Subject: Preliminary Plat review for 19-lot residential subdivision, located in the N ½ of the SW ¼ of Section 13, Town of Eagle. Tax Key No. EGLT 1779.999.001

PRELIMINARY PLAT
OF
LONG MEADOW

MEMORANDUM

Date: March 4, 2025
To: Rebekah Leto, Town Planner
From: Tim Lynch, P.E., Mike Flesch P.E., Town Engineer
Subject: Long Meadow. Subdivision February Submittal Review, Town of Eagle Parcel # EGLT1779.999.001

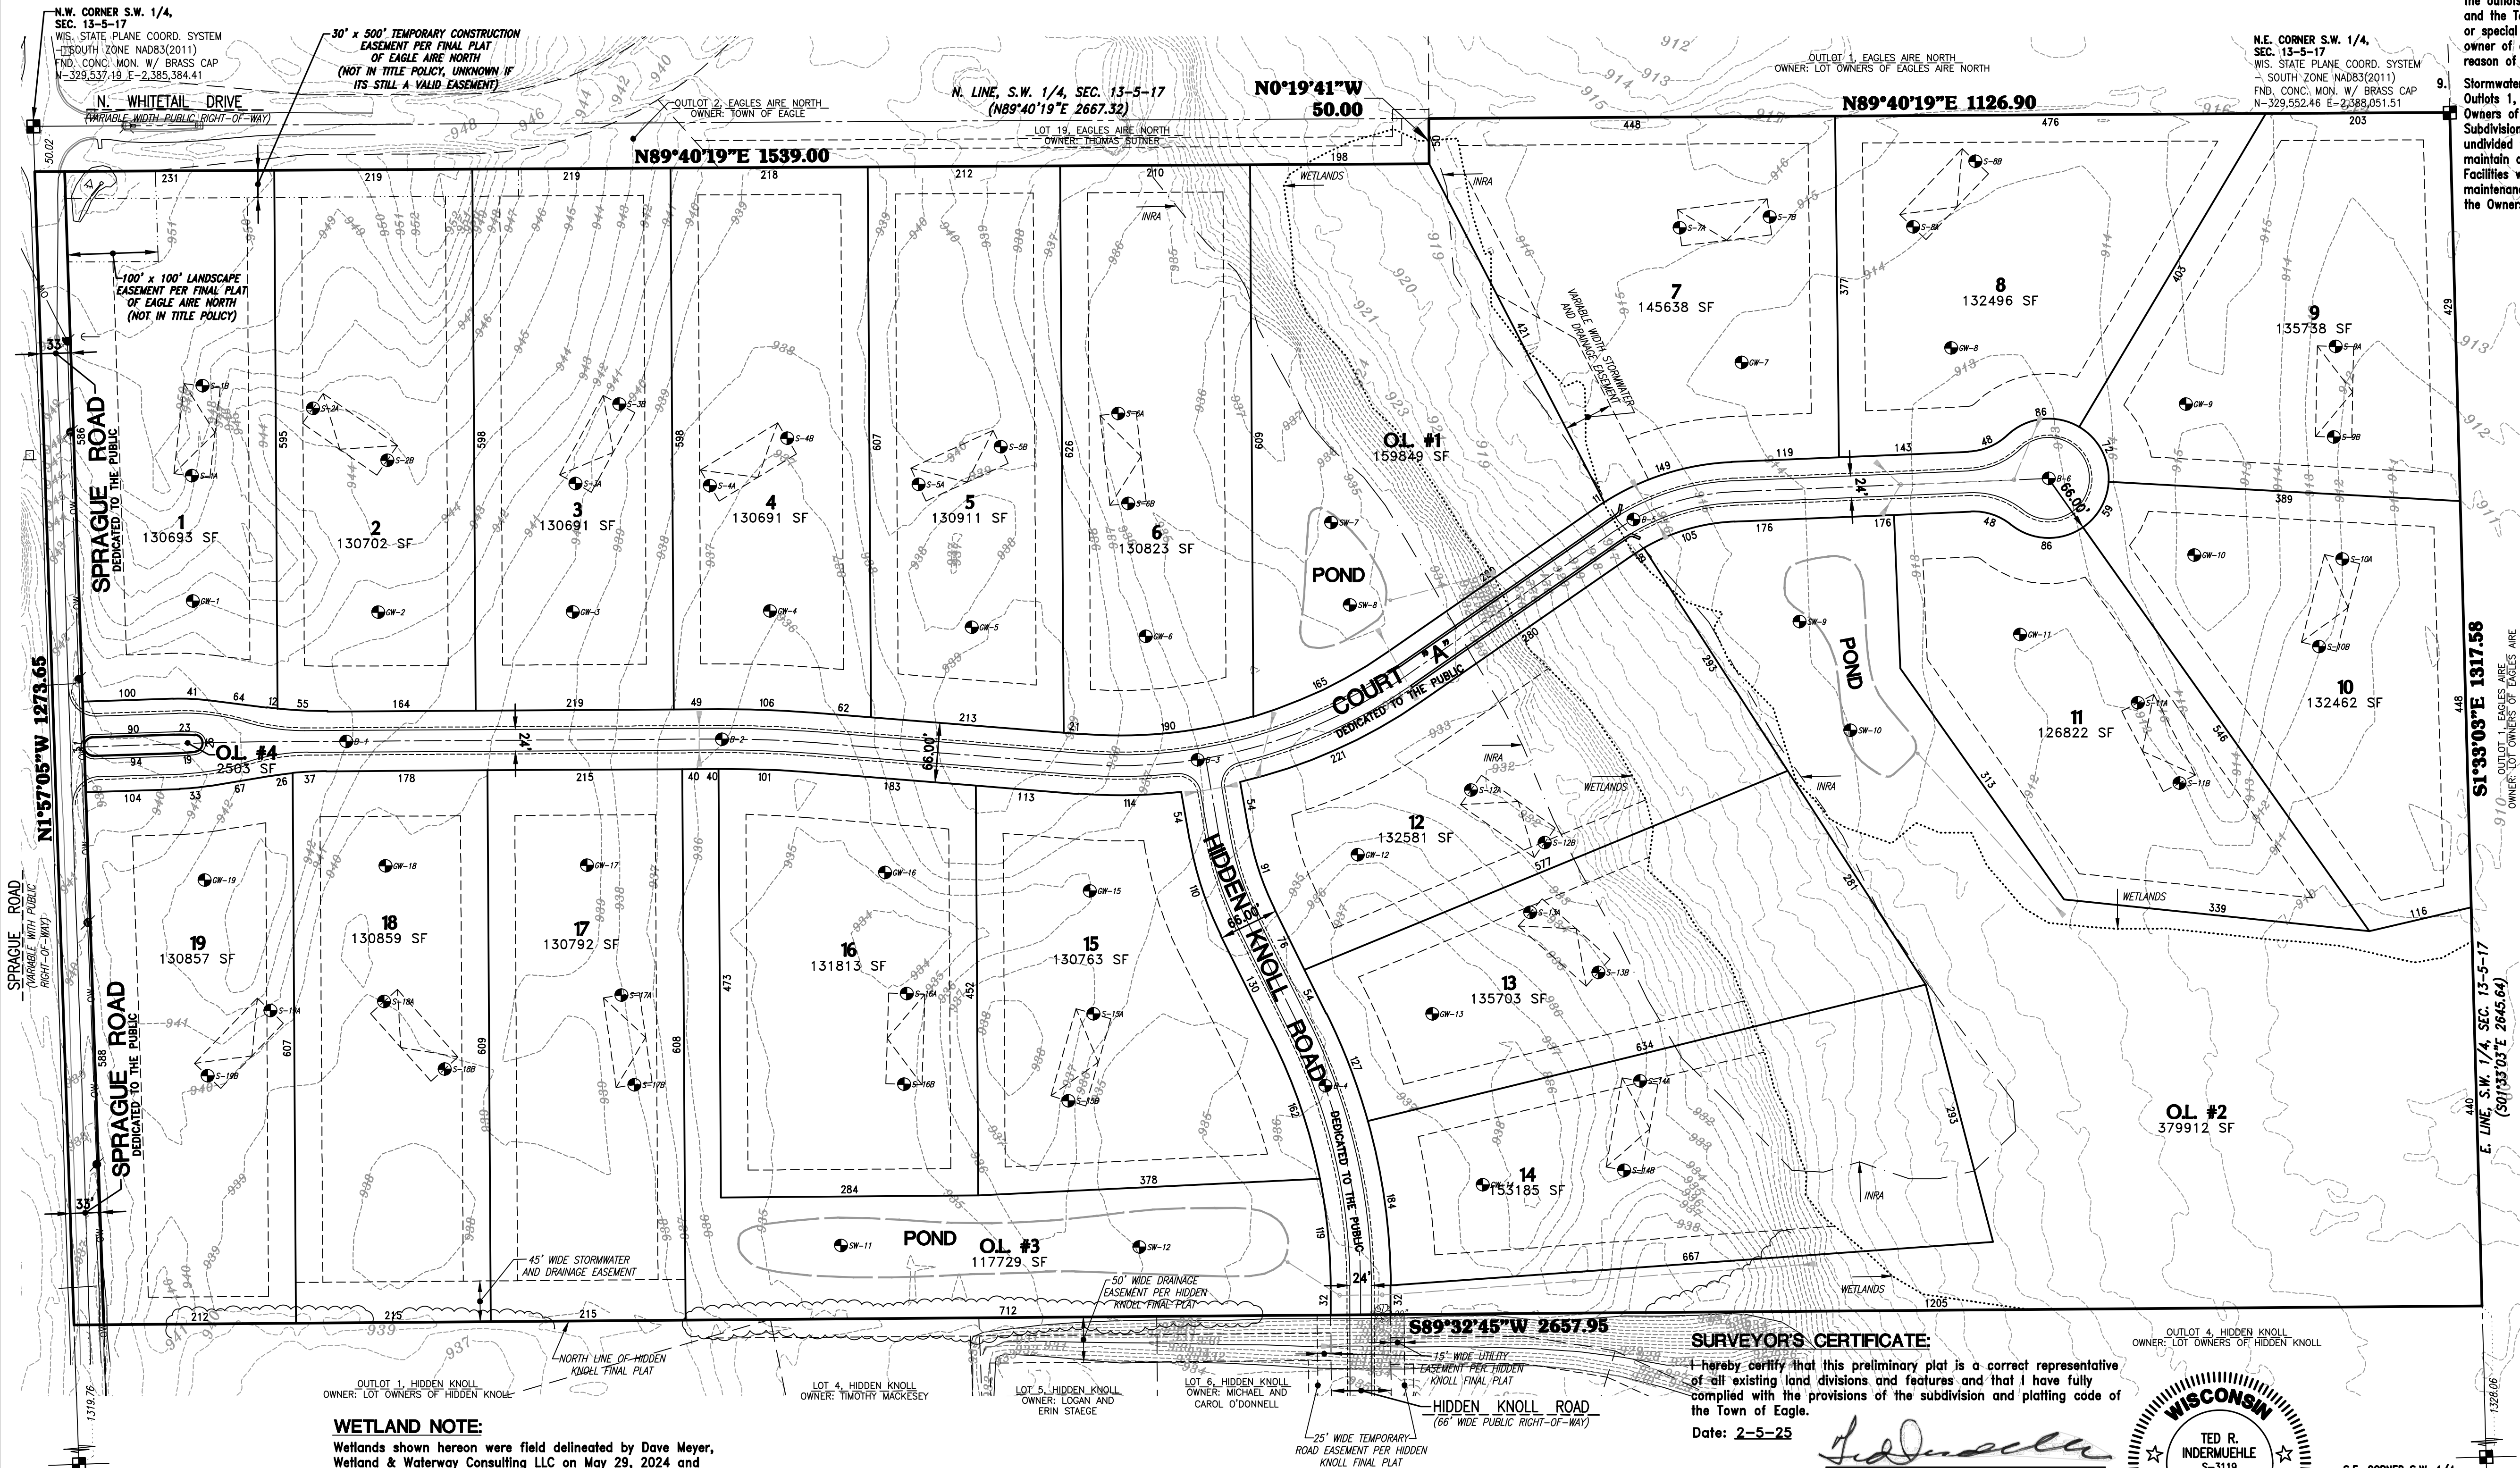
1. Wetlands must be identified both onsite and within 50 feet of the property boundary.
2. Buildings within 50 feet of the site boundary must be shown, along with their use, as required by Waukesha County. The dwelling at W349S8280 N Whitetail Dr appears to be within this 50-foot boundary and should also indicate a break in topography.
3. Building setbacks are not labeled, preventing verification against applicable zoning regulations. These should be clearly indicated.
4. Lot 1 must show restricted access to North Whitetail Drive.
5. Lots 1 and 19 must show restricted access to Sprague Road.

6. Check for duplicate subdivision name: "LONGMEADOW" exists in Oconomowoc (Doc #3220622, Bk 52 Pg 120-124, recorded 11/05/2004).
7. Wetland setbacks are not shown and must be added.
8. Right-of-way width for Sprague Road must be clarified and labeled consistently with surrounding recorded surveys.

9. Road width on the north and south sides of Outlot 4 is not labeled and must be provided.
-

10. Plot stamp along the left margin must be removed to maintain a 1-inch margin per §236.20(1)(a).
11. Plat must be legible (e.g., contour labels, Surveyor's Certificate, lot footages).
12. Exterior and interior monumentation is missing and must be shown.

13. Label easements along the north line per Eagles Aire North (lines are shown but not labeled).
14. Label 20' drainage easement along the south line per Hidden Knolls (lines are shown but not labeled).
15. Correct spelling error under Sprague Road (misspelled "Width").
16. Clarify the meaning of "Minimum Offset / Minimum Setback" in the upper left corner.

35. Hammerhead removal details need to be added, along with a corresponding plan note.
36. Acceleration and deceleration lanes must be added to Sprague Road—verify they fit within the right-of-way.

40. Mounds near the entrance are shown on Lots 1 & 19—clarify if they are within a landscape easement and whether lot owners are permitted to remove them.

41. Lot 4 drainage conflict—the main drainage swale overlaps the septic system location and must be addressed.
42. Driveway culvert sizes and locations for each lot must be shown.

43. Culvert and storm sewer sizes are missing—these should be provided for all applicable sheets.
44. Drainage easements or right of way is needed at the intersection of Court “A” and Hidden Knoll Road.

45. The Sprague Road cross culvert near Lot 1 must be extended to accommodate the acceleration lane.
46. Vision corner evaluation for the Sprague Road intersection must be shown—determine if restrictions are needed. (*Sheet C2.01*)

47. Acceleration and deceleration lanes on Sprague Road must be included. (*Sheet C3.00*)
48. Boring logs for septic field locations must be provided.

Based upon the above information, staff recommends the Planning and Zoning Commission recommend to the Town Board **conditional approval** of the Preliminary Plat dated February 5, 2025, based on the following conditions being met, **prior to the submittal** of a revised Preliminary Plat or a Final Plat, unless otherwise noted:

1. All comments of the Town Engineer Memo dated 3/4/2025 shall be complied with. Preliminary Stormwater Approval shall be granted prior to land altering or the submittal of a Final Plat or revised Preliminary Plat. If Preliminary Stormwater Approval requires the substantial modification of the layout as shown on the 2/5/25 plat, a revised Preliminary Plat is required to be submitted to all entities.
2. Modify the zoning requirements to state the road setback is 35 ft. and modify the building envelopes shown on the plat to match.
3. Existing wells and septic systems within 50 ft. of the exterior plat boundary shall be shown on the plat.
4. Buildings within 50 ft. of the exterior plat boundary shall be shown on the final plat.
5. Any existing farm drain tiles shall be identified on the plat, including location, purpose and status.

6. Vision corner easements shall be placed on Lots 1, 12, 15 and 19 in accordance with Section 500.562 of the Municipal Code. Restrictive language of the easement area shall also be placed on the plat.

7. The Town Board must approve a waiver from the 2.5:1 maximum Depth to Width Ratio requirement for Lots 1-6, 13-14 and 17-19 as they do not meet this requirement by approximately 17-33 feet. If approved, a note shall be added that states, "The Town Board waive the 2.5:1 depth to width ratio requirement for Lots 1-6,13-14 and 17-19 on _____".

9. The wetland and INRA areas on Lots 6 and 12-14 shall be contained within an "Open Space Easement" to ensure the property is consistent with the purpose of preserving the area as open space in perpetuity. The easement language can be incorporated into the Land Management Plan noted above or noted directly on the plat.
